**CITY OF MENASHA
PLAN COMMISSION
Menasha City Center
100 Main Street, Menasha
Rooms 132 and 133**

**December 7, 2021
3:30 PM**

AGENDA

To: Plan Commission
From: Community Development Department/SS
Date: December 7, 2021
Re: **Special Use Permit and Site Plan Review – TriCity Auto – 1415 Appleton Road (Parcel 6-01651-00)**

SHEET TITLE
SITE PLAN

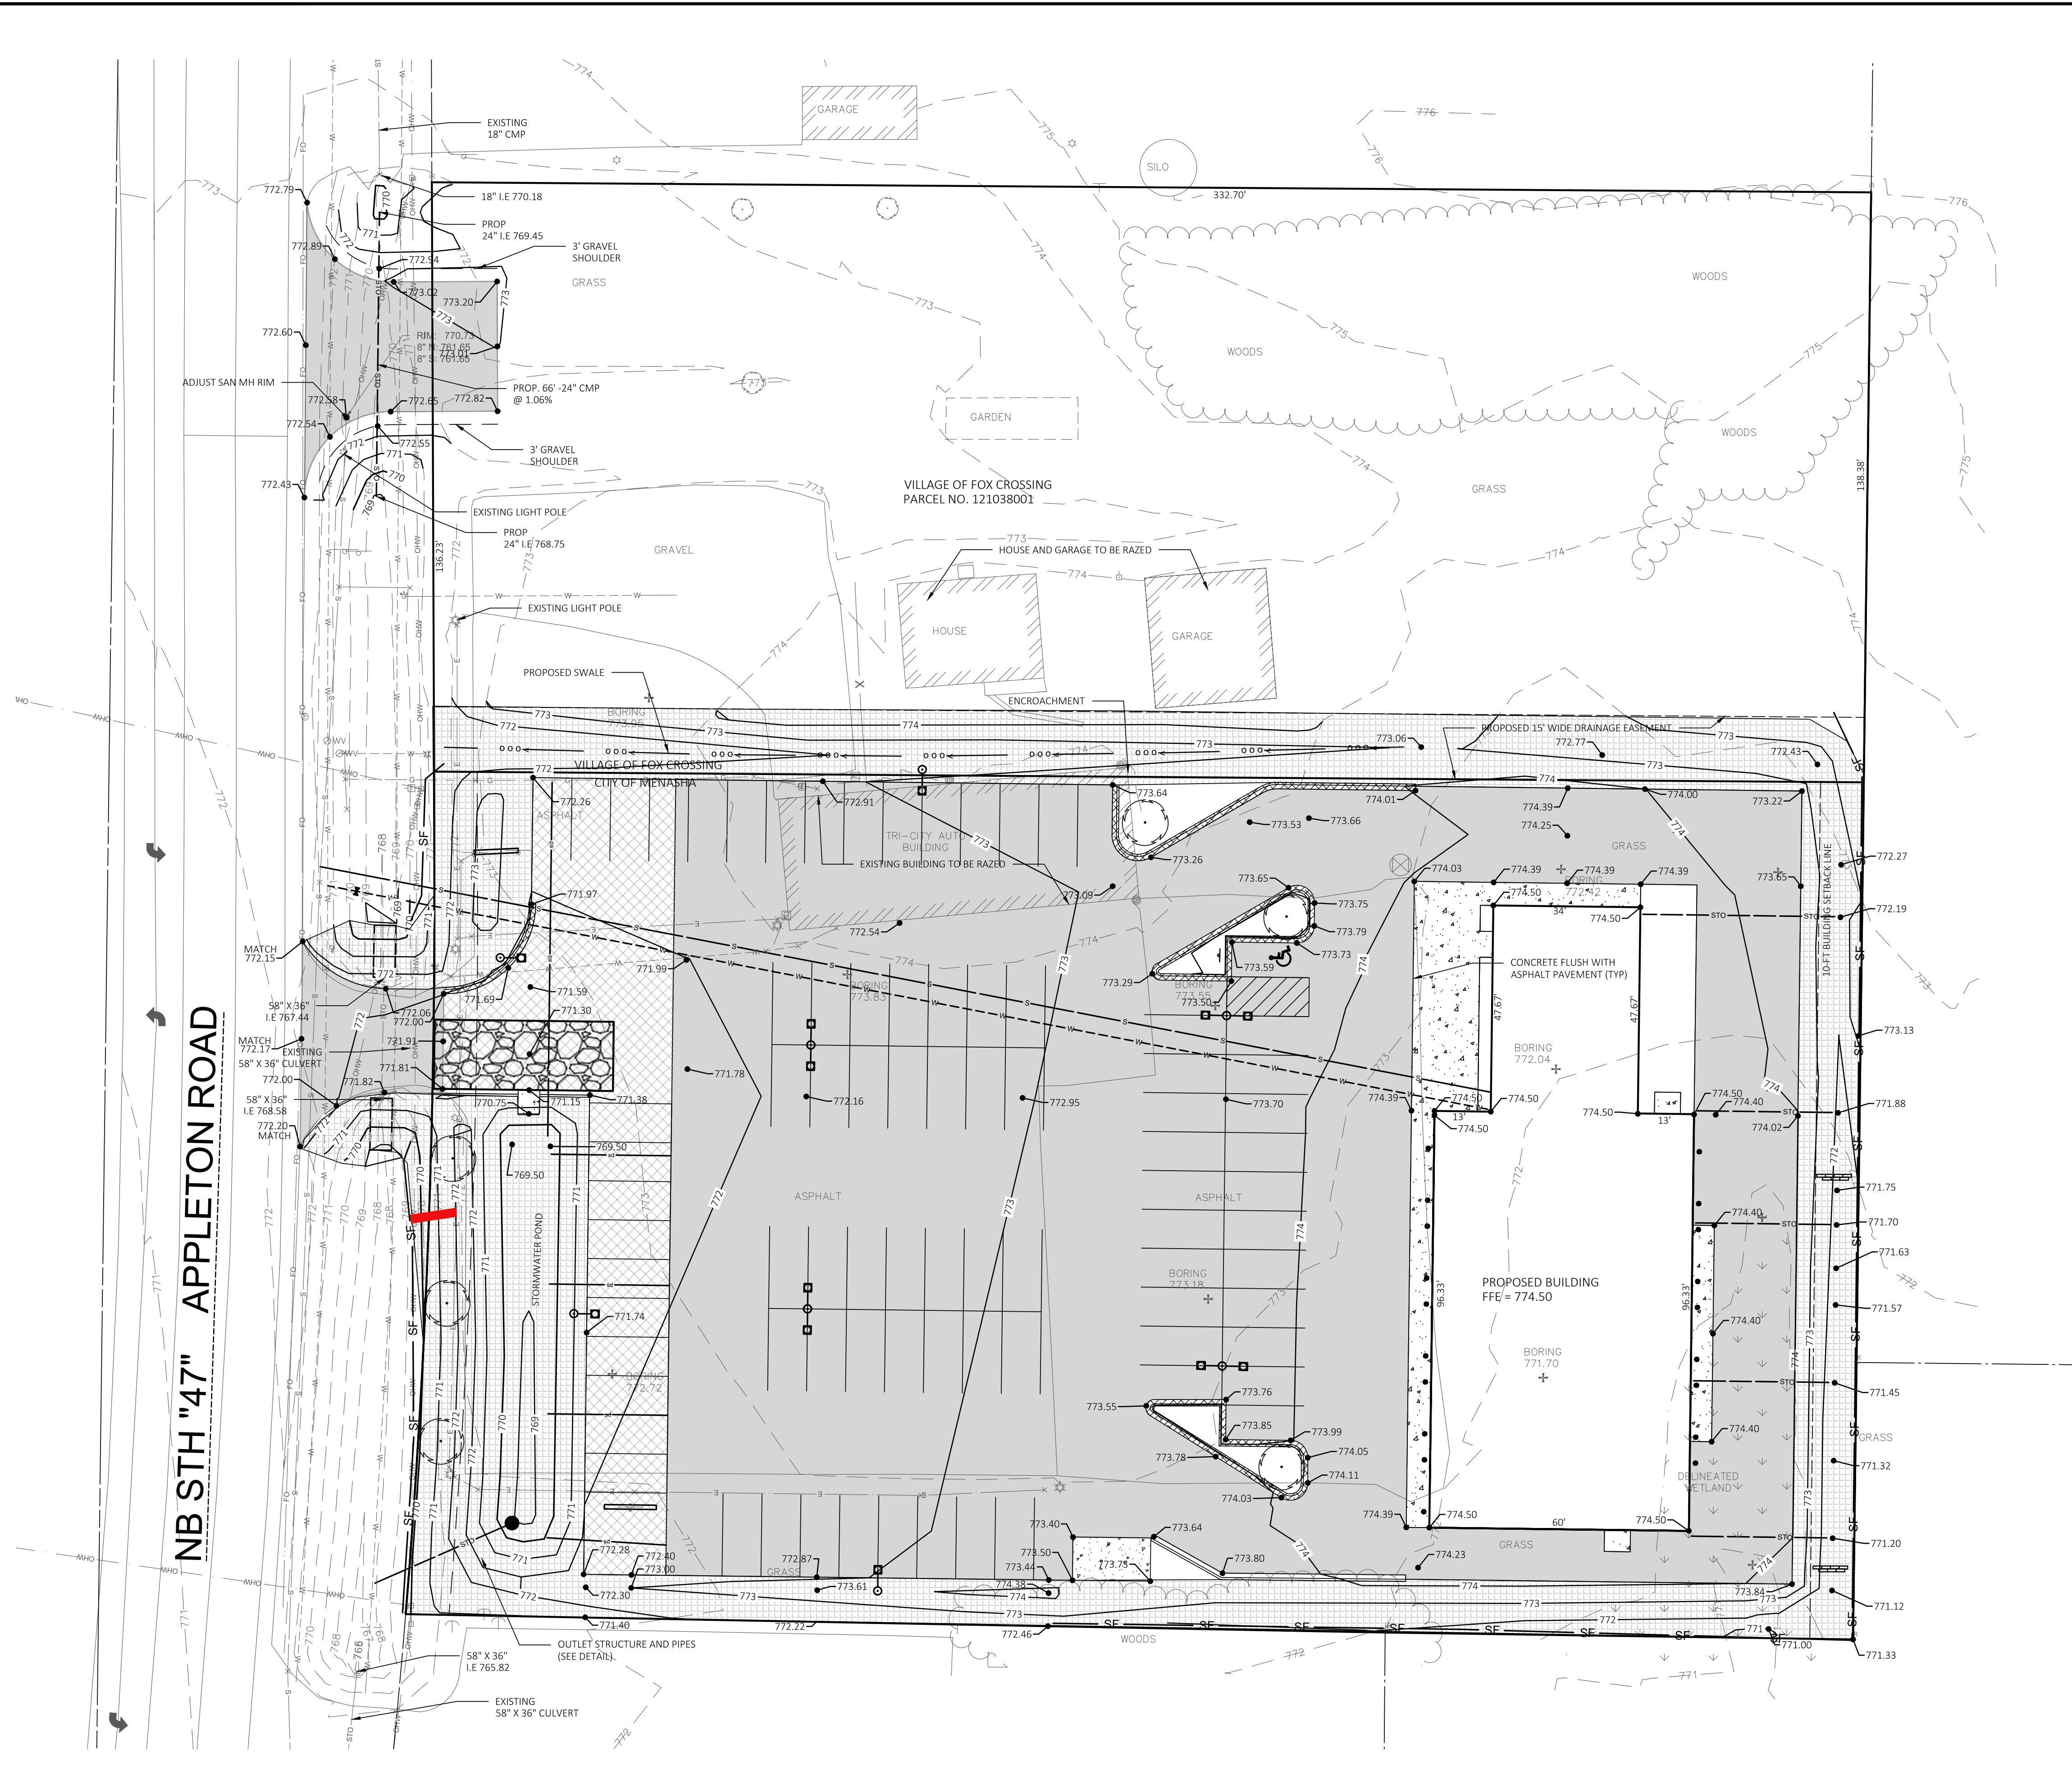
Mechanical equipment is not noted on the site plan. Any mechanical equipment will be required to be screened per Section 13-1-12(f)(6) of the Zoning Code.

- 1) Prior to the issuance of permits, a stormwater and site improvement agreement must be recorded for the proposed development.**
- 2) Prior to issuance of permits a final stormwater management plan is submitted and approved by the Public Works Department.**
- 3) The Special Use Permit is approved.**
- 4) A lighting plan meeting section 13-1-12(h) is submitted and approved prior to executing a site improvement agreement.**
- 5) A landscape plan meeting section 13-1-12(g) is submitted as recommended in staff memo dated December 7, 2021 and approved prior to the execution of a site improvement agreement.**
- 6) Any ground mounted mechanical equipment is screened meeting section 13-1-12(f)(6).**
- 7) A dumpster enclosure is submitted meeting section 13-1-12(e)(5) prior to the execution of a site improvement agreement.**

TRI-CITY AUTO
 MENASHA, WISCONSIN
 LIGHTING LAYOUT

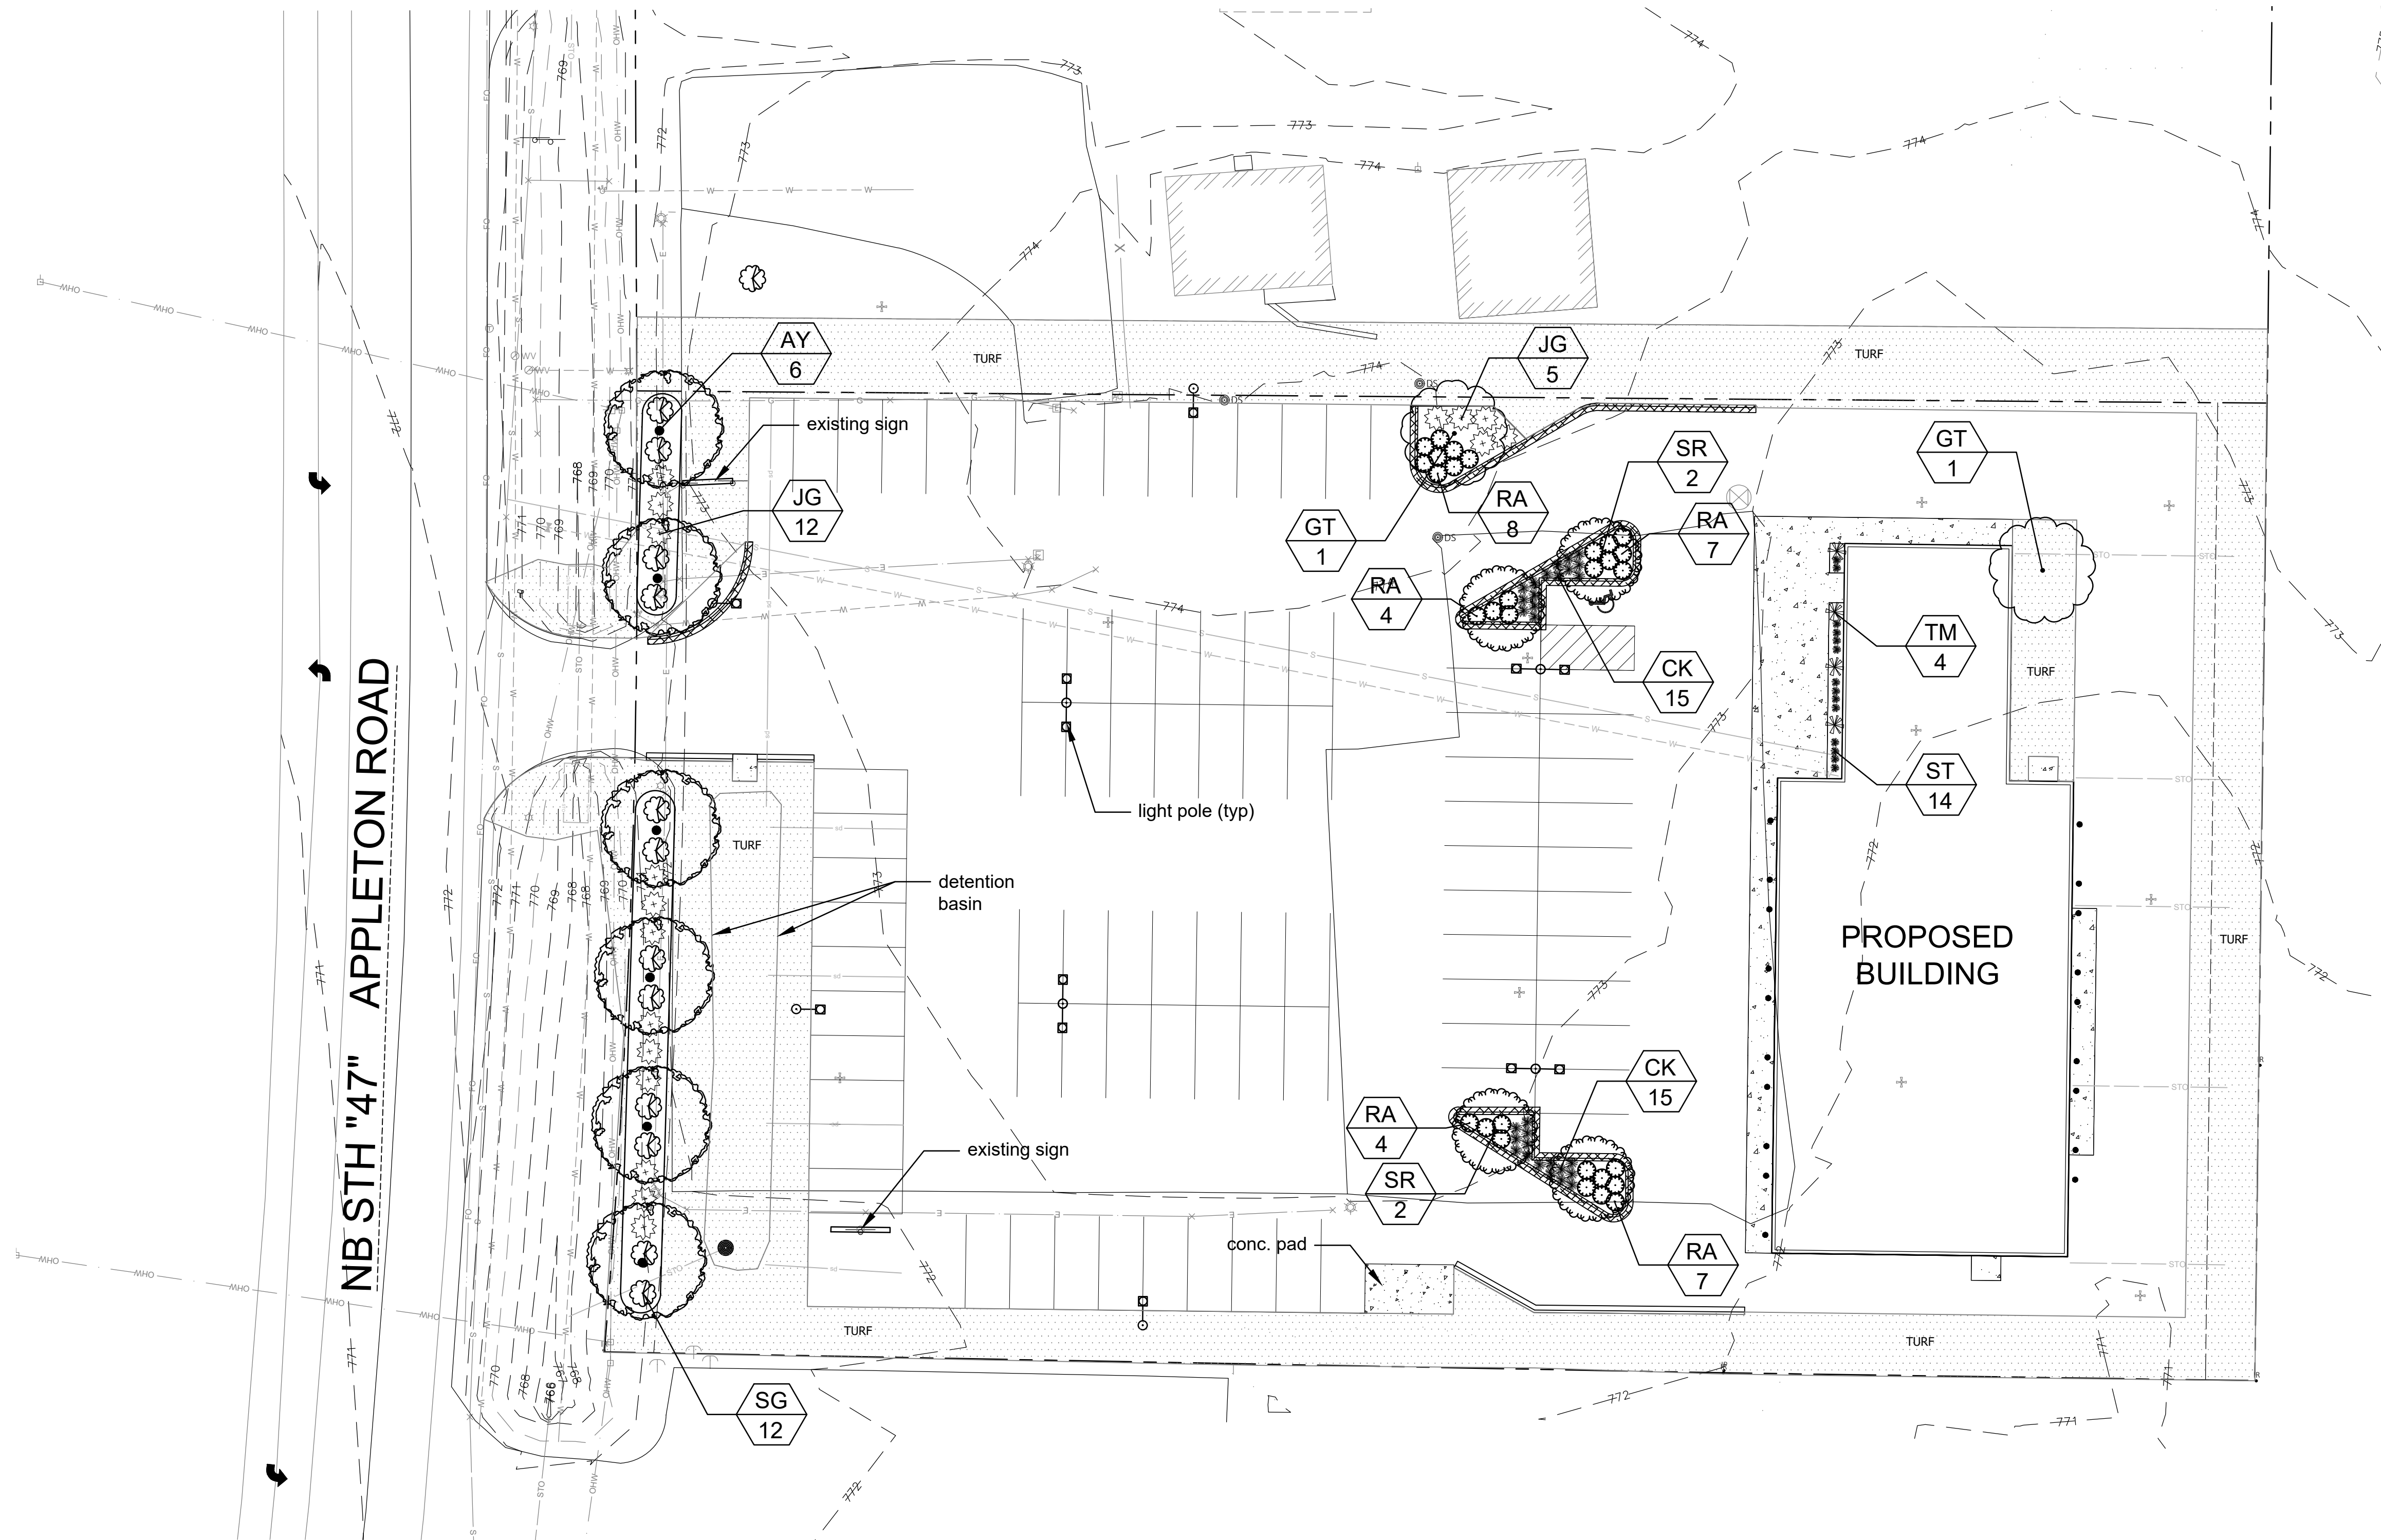
All of the fixtures submitted are full cutoff fixtures meeting requirements of the code. However, the submitted plan does not meet code in a few areas: 1) the maximum light trespassing on the property lines north and south in a few areas exceeds 0.5fc 2) the proposed height of the light poles is currently taller than the principal structure being 17'2" 3) the maximum foot candles of the parking/outdoor display area exceeds the max 5.0 footcandles. Staff is recommending prior to issuance of a site improvement agreement, a lighting plan meeting the lighting ordinance of Section 13-1-12(h) of the Zoning Code be submitted and approved.

**Sheet Title:
ELEVATIONS**

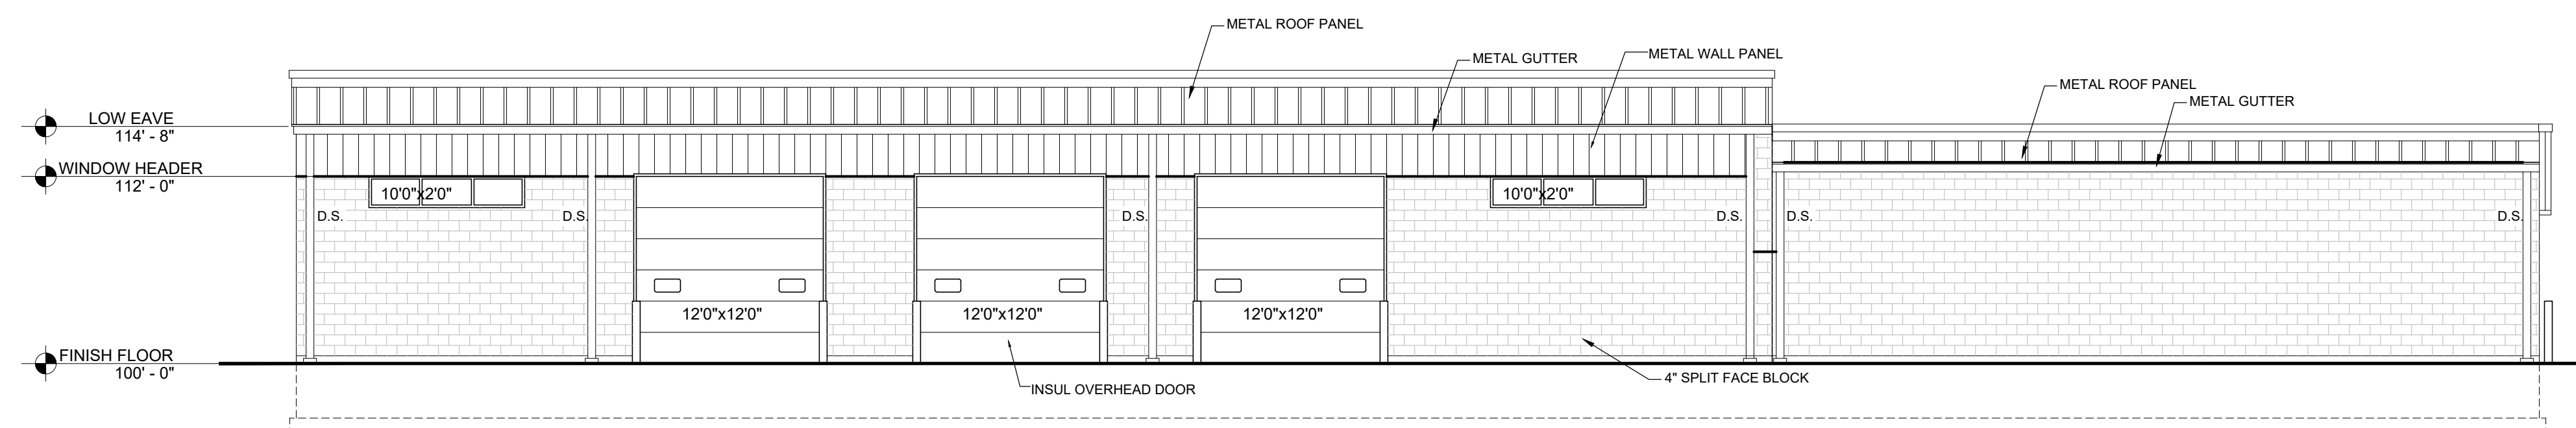
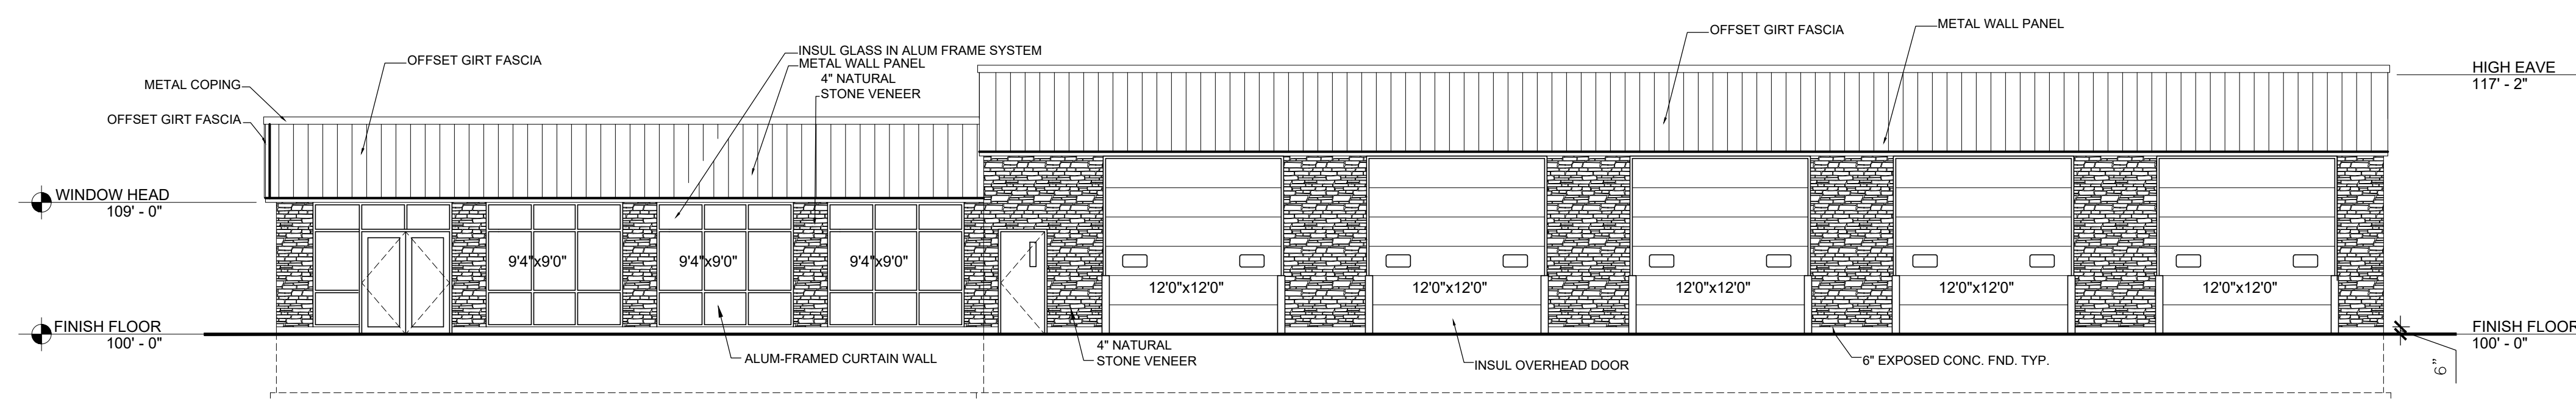
BUILDING DATA:		
6,345 TOTAL SQUARE FEET ALL SIDES		
O.H DOOR:	1,152 S.F.	18%
WINDOWS/WALK DOOR	626 S.F.	10%
NATURAL STONE/SPLIT FACE STONE	2,847 S.F.	45%
METAL WALL PANEL	1,730 SF.	27%
